Highland Uranium Mill Site

**License Amendment
Request - RAIs
August 14, 2012**

Highland Mine License Amendment Request

Highland RAIs – Temperature Anomalies

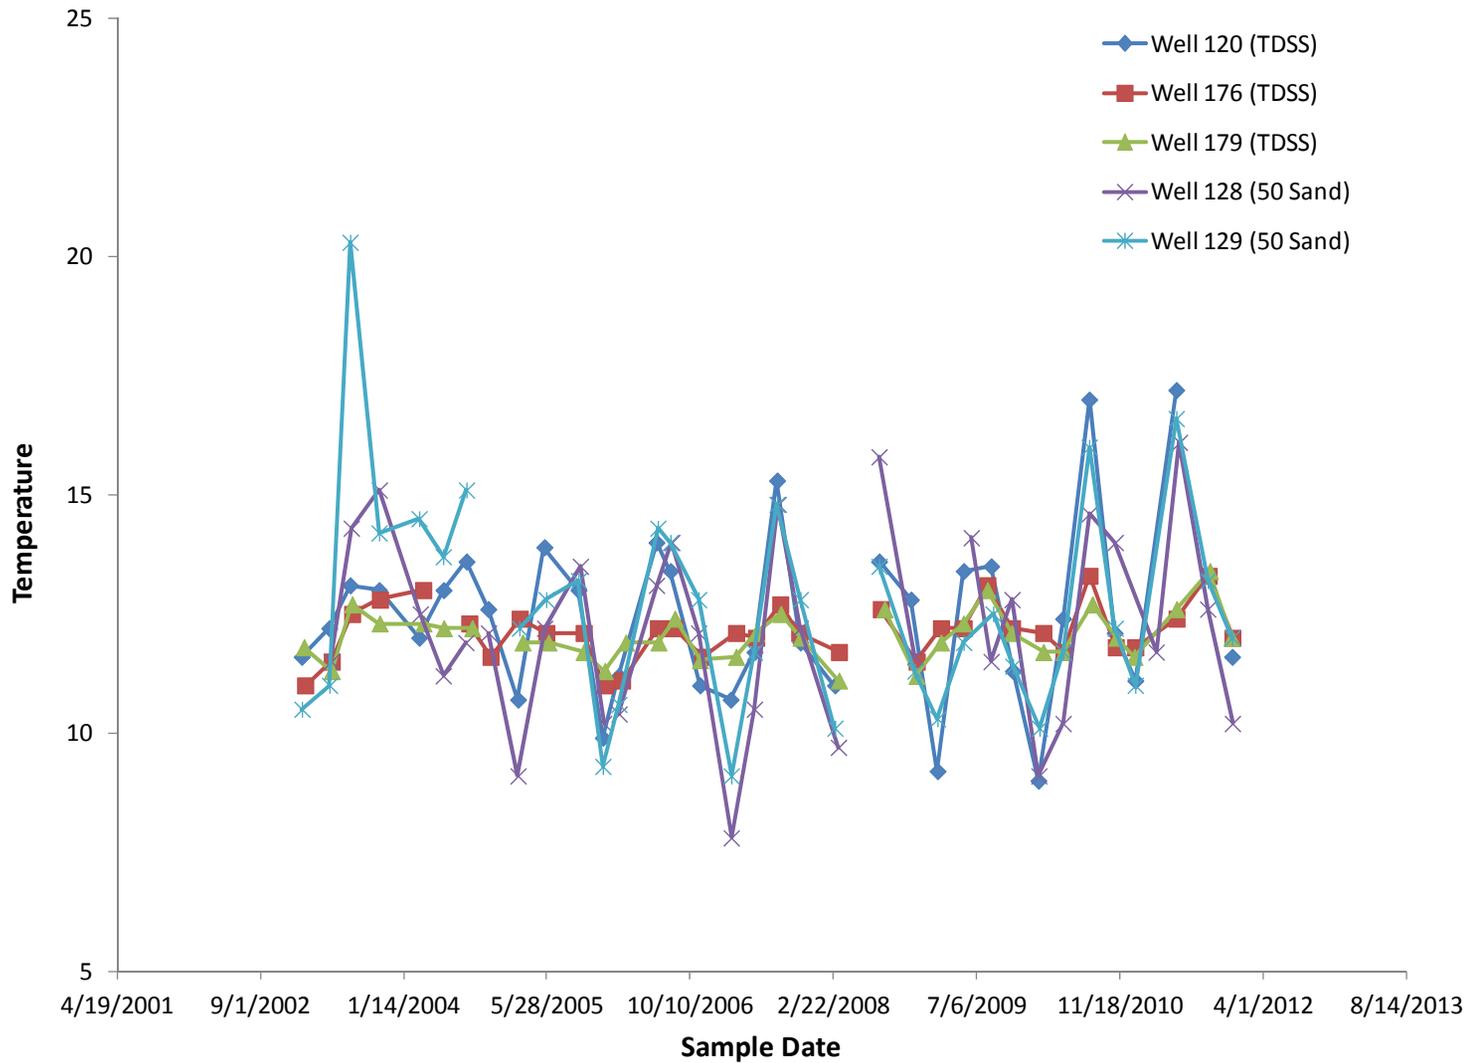
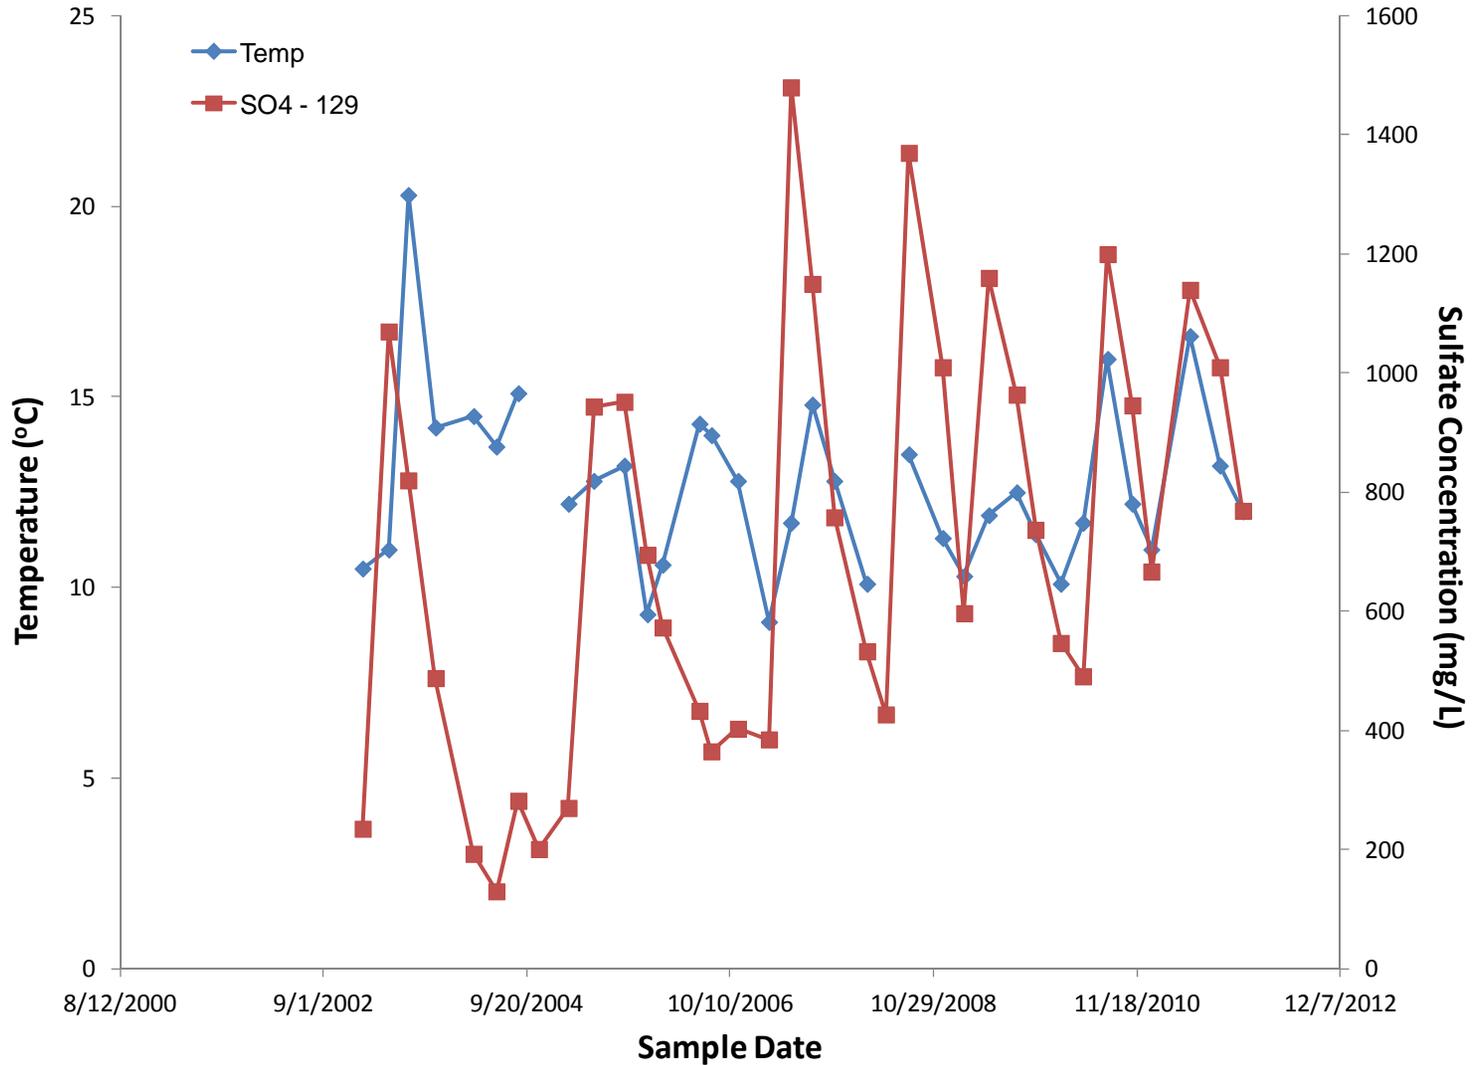
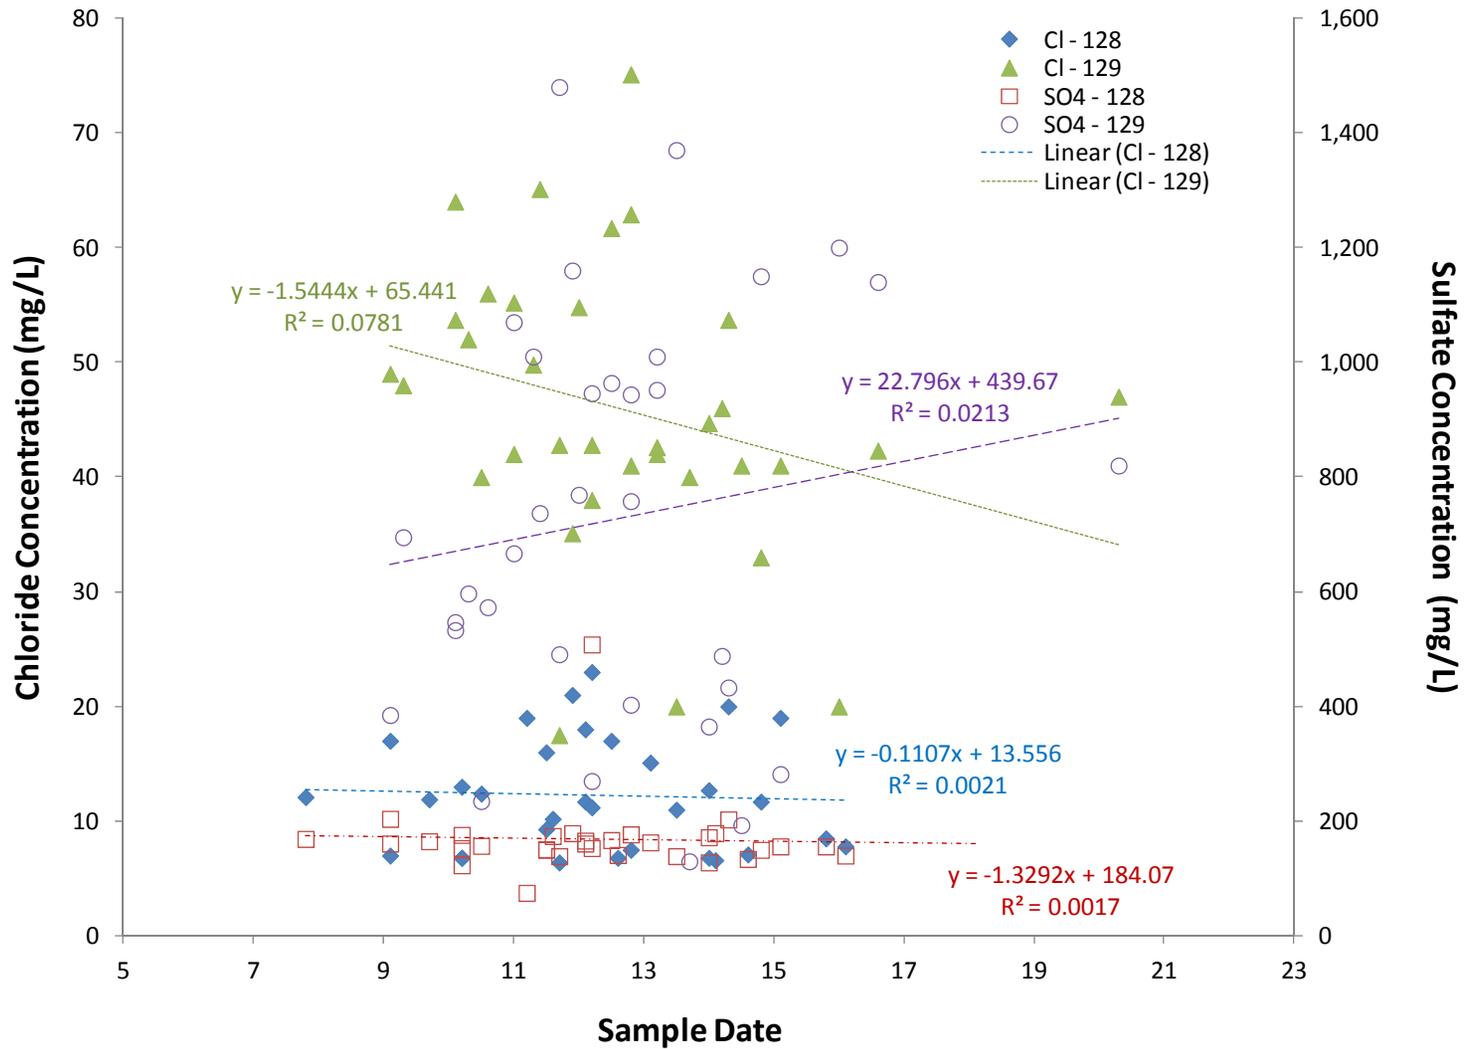
GC-4: Provide technical basis for variations in water temperature and solute concentrations in Wells 129 and 128.

- Slightly elevated constituents at wells downgradient of MFG-1; BBL-2 elevated selenium, BBL-3 elevated $^{226}\text{Ra} + ^{228}\text{Ra}$
 - Isolated occurrences, Se lower at MFG-1 and is very low or non-detectable at all downgradient wells
- Constituent trends vs. temperature in Wells 128, 129 in OBSS vs. 120, 176, and 179 in the TDSS
- Not a dynamic flow system

Highland RAIs – Geochemistry

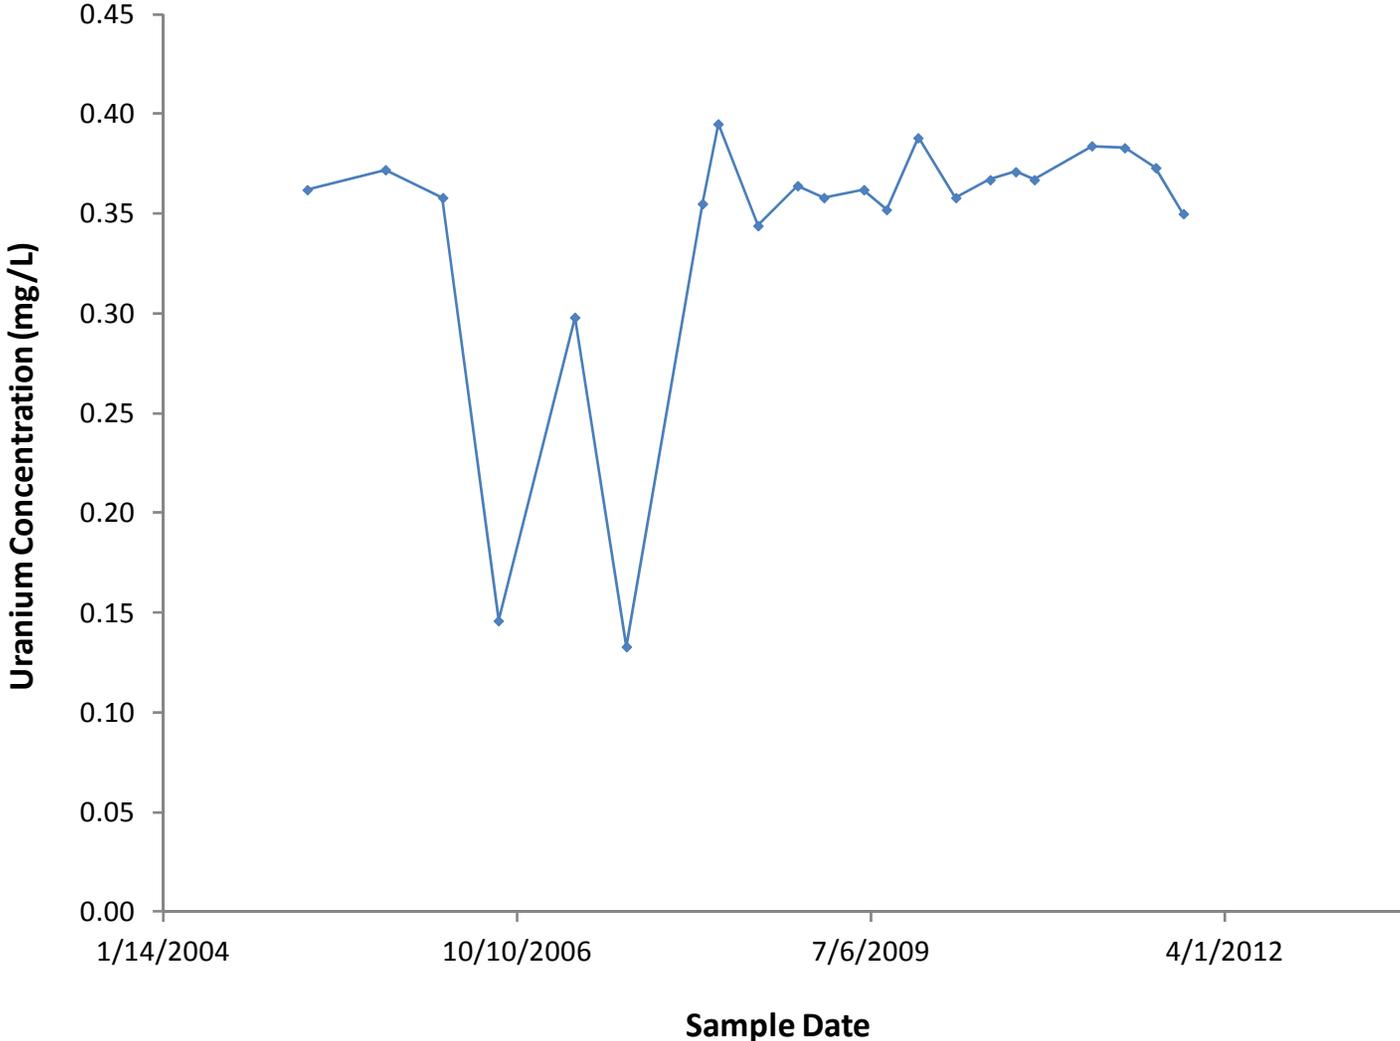
GC-3: Provide basis for conclusion that U concentrations in MFG-1 are not anticipated to increase.

- Trend analysis indicates no upward trend
- Trends in adjacent wells east of tailing (e.g. Well 125) show decreasing water levels and decreasing concentrations of major constituents
- Calculated Upper Prediction Limit (UPL) for 100 future observations is 0.423 mg/L

Highland RAIs – Groundwater Flow North of Tailings

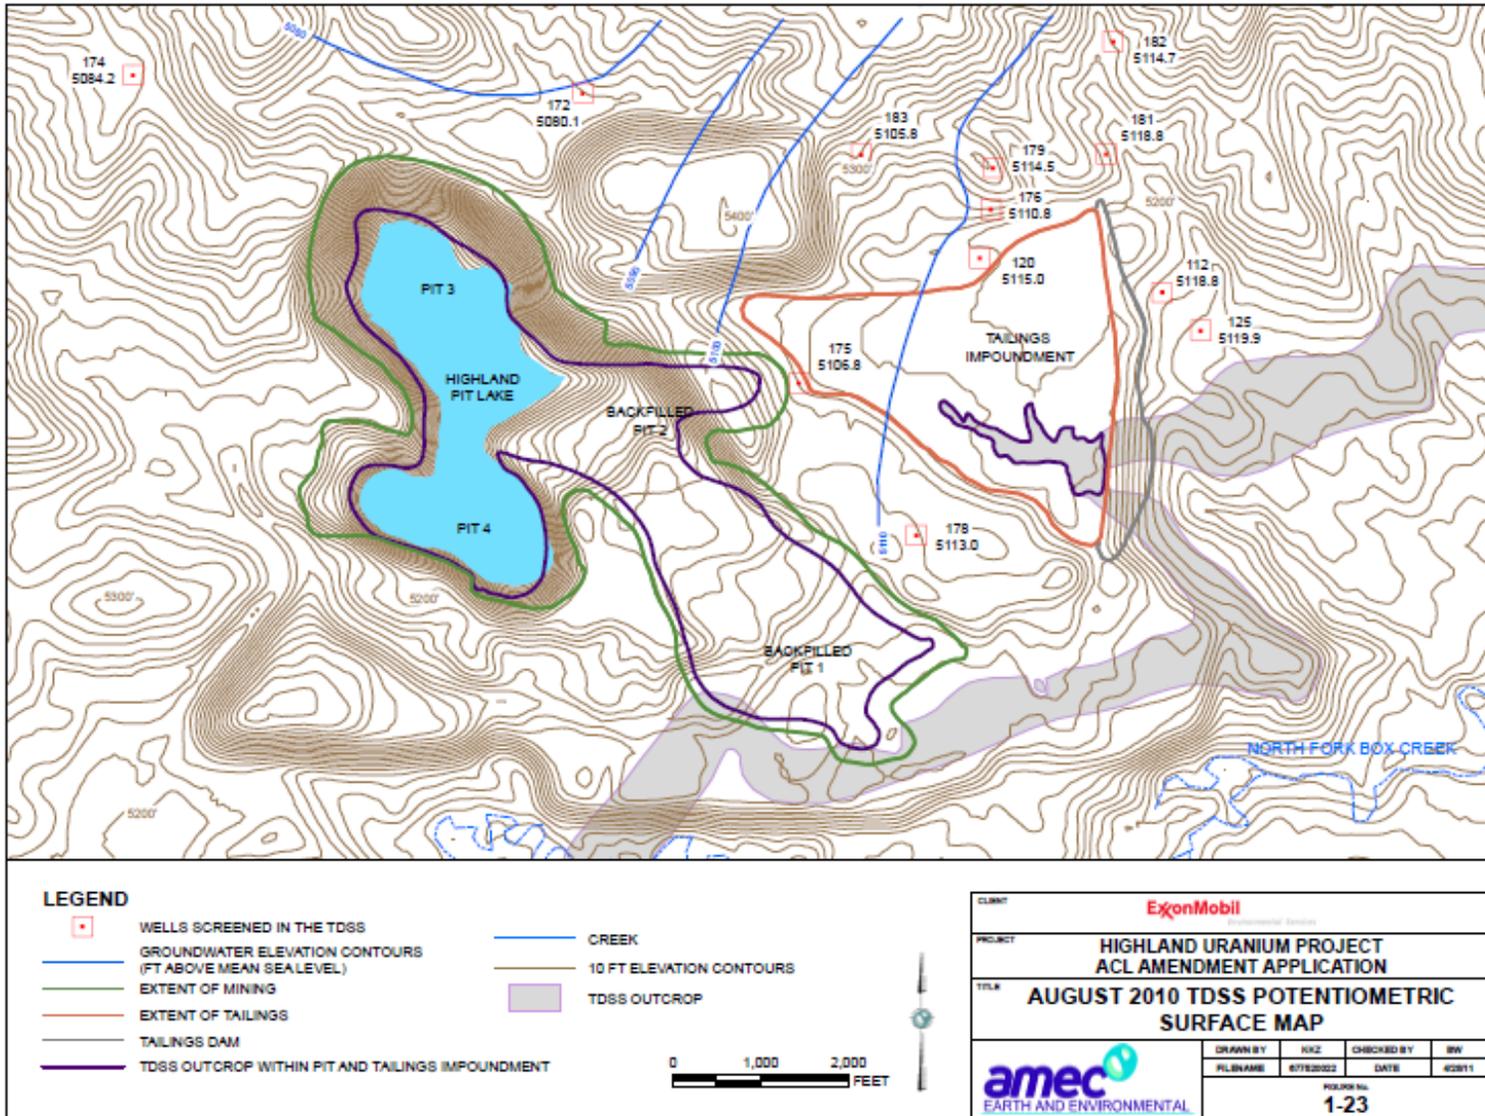
H15: Provide technical justification for not evaluating a potential flow pathway north of the tailings dam.

GC-5: Provide the technical bases for excluding a proposed point of compliance well located in the OBSS north of the tailings impoundment.

- It is recognized that data suggest a possible groundwater flow path in the TDSS to the north of the tailings impoundment
- Elevated chloride and sulfate levels in wells north of tailings
- Redox conditions will limit migration of hazardous constituents
- Groundwater flow path in OBSS is toward the lake, not to the north
- POC wells designated for the uppermost aquifer, which is the TDSS at the Highland site.
 - *“In practice, the POC will be located within a vertical surface representing the intersection of the down-gradient edge of the reclaimed tailings impoundments with the uppermost aquifer.” (Alternative Concentration Limits for Title II Uranium Mills – January 1996)*
